SUBJECT: Forwards util 790731 response to NRC 790712 request re undervoltage protection. Requests info be withheld (ref 10CFR2.790).

Subject: Undervoltage Protection  
RG&E Ginna Nuclear Power Plant  
Docket 50-244

Subject: Undervoltage Protection  
R.E. Ginna Nuclear Power Plant  
Docket No. 50-244

FIG. 1 SINGLE LINE DIAGRAM TRAIN A  
 EXISTING UNDERVOLTAGE SYSTEM

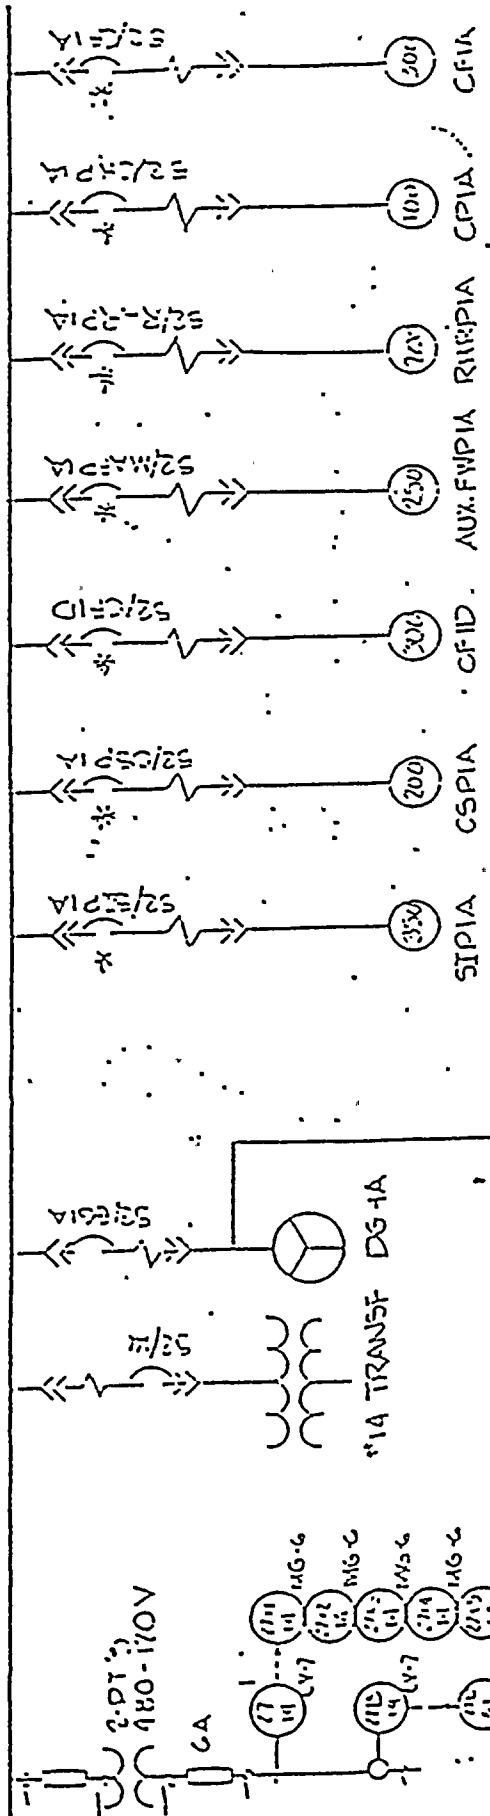
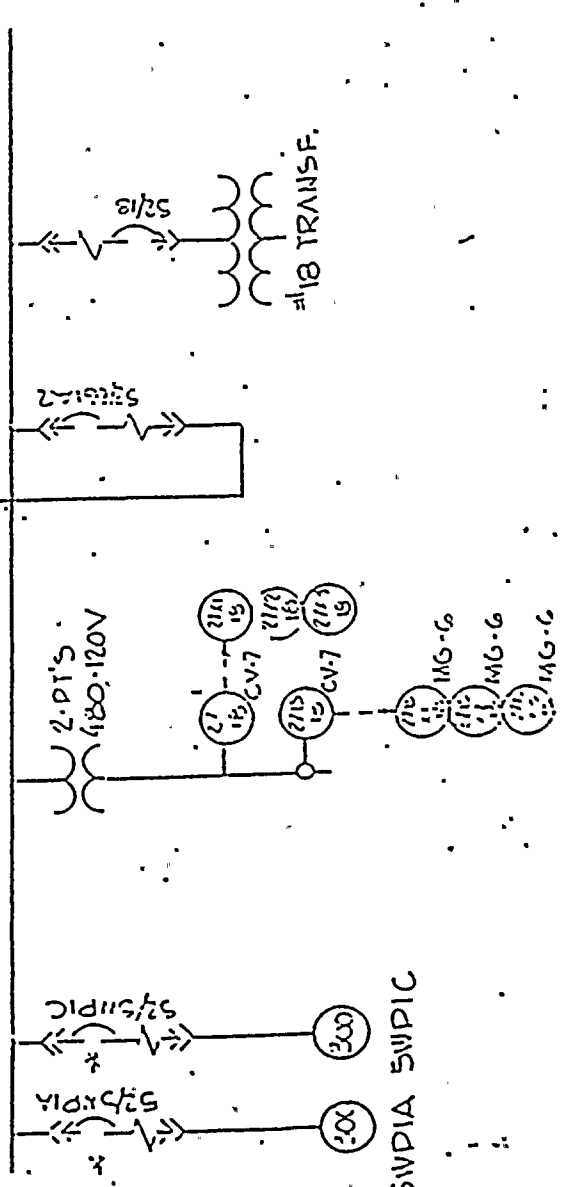
Question 1. Provide the voltage setpoint trip and time delay and the tolerance on the 4160 volt side for the second level voltage protection monitors in the Technical Specification.

Response: As shown on the enclosed single line for train A (from our submittal of May 1, 1978), the undervoltage load shedding and sequencing system is entirely at the 480V level. Since there are no 4160V safety related loads, there are no undervoltage protection monitors for the load shedding and sequencing system at that level.
